MEMO

Date: July 7, 2026
To: Mayor and City Council
From: Shannon McGuire, Assistant Director of Plan Services
By: Adair Bright, AICP, Senior Planner
CC: File
Re: Application #PL2026-035 – REZONING & PRELIMINARY DEVELOPMENT PLAN
Dillon's Grocery Store with Fueling Kiosk/Canopy and Commercial Liner Buildings
Phillips Edison & Company, Applicant

Figure 1 - Proposed Landscape Plan Illustrating the Location of the Proposed Additional Screening Trees (Highlighted in Green and Western Façade in Purple)

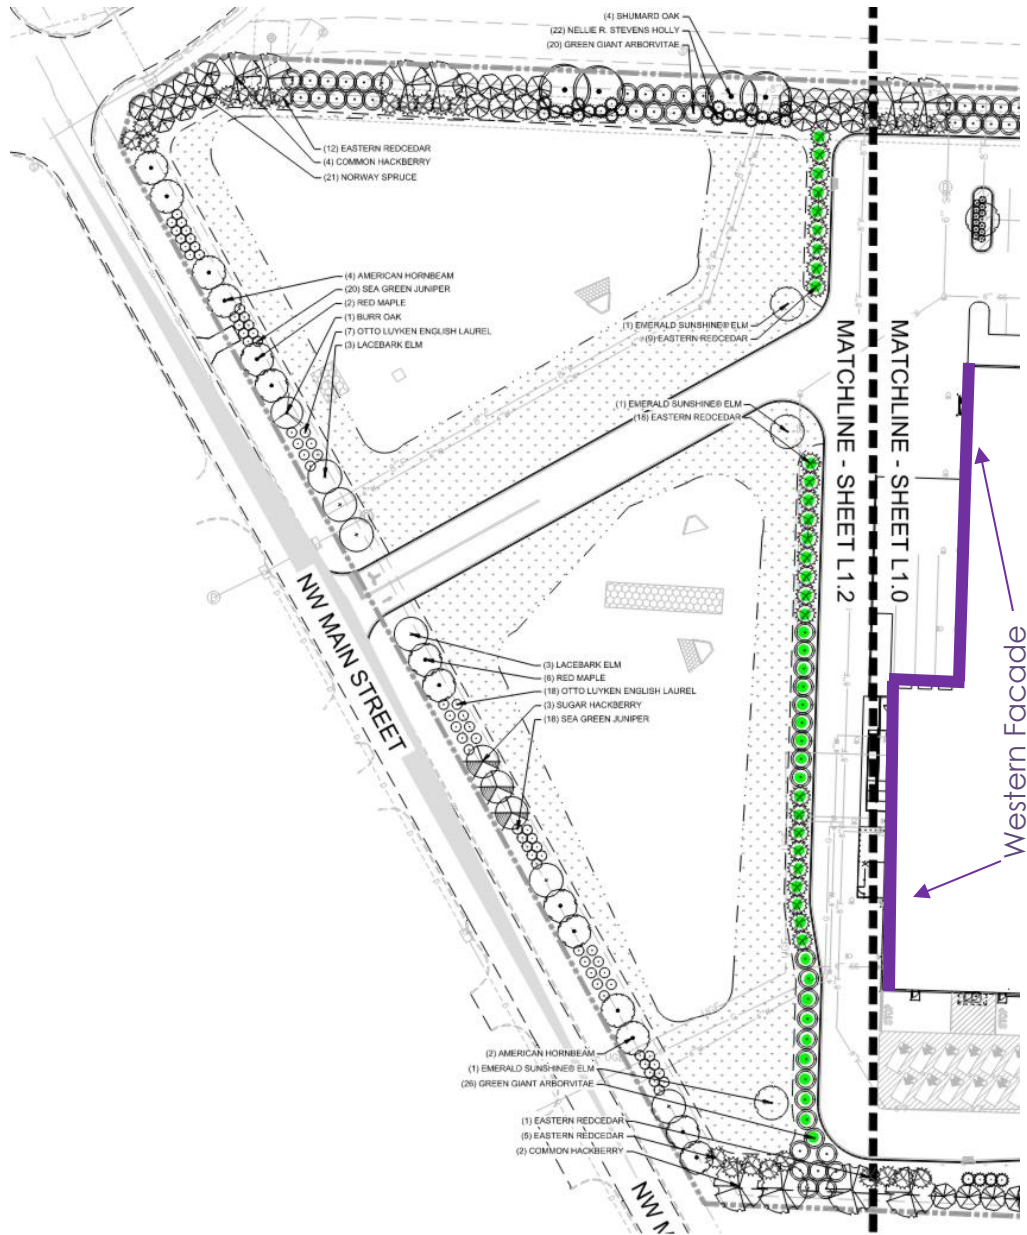
In response to the Planning Commission's recommendation, the Applicant submitted revised plans that include additional landscaping adjacent to the drive aisle along the west façade of the grocery store (Figure 1). The Applicant also provided additional renderings and perspective views intended to better illustrate the visibility of the west elevation from surrounding public rights-of-way. Staff has reviewed the revised submittal; however, the recommendation remains unchanged. While the additional landscaping and visual exhibits provide further context regarding the visibility of the west elevation, they do not address the underlying architectural concerns associated with the requested modification. Accordingly, staff continues to recommend that the Applicant comply with the architectural requirements established by the UDO.

Staff also appreciates the Applicant's willingness to incorporate additional landscaping; however, the proposed vegetation does not satisfy either the letter or the intent of the UDO's architectural standards. The landscaping is intended to screen the west façade rather than enhance the architectural treatment of the building itself. While the proposed Eastern Redcedar and Green Giant Arborvitae trees can ultimately reach heights sufficient to provide screening, they will be installed at an initial height of only 5 to 8 feet. Given that the west façade is approximately 26 feet tall and is located at a higher elevation than the proposed planting area, it will take many years before the landscaping provides meaningful screening. In addition, the proposed trees are located adjacent to and over proposed utility infrastructure where future maintenance or utility work could necessitate their removal, reducing their long-term effectiveness as a permanent screening element (Figure 2). For these reasons, staff does not believe the proposed landscaping is an appropriate substitute for compliance with the City's architectural standards.

6. The western façade shall comply with all applicable requirements of Section 8.080.B. Specifically, the façade shall incorporate no fewer than three (3) different Class 1 or Class 2 building materials, with those materials collectively comprising at least fifty percent (50%) of the primary façade area.
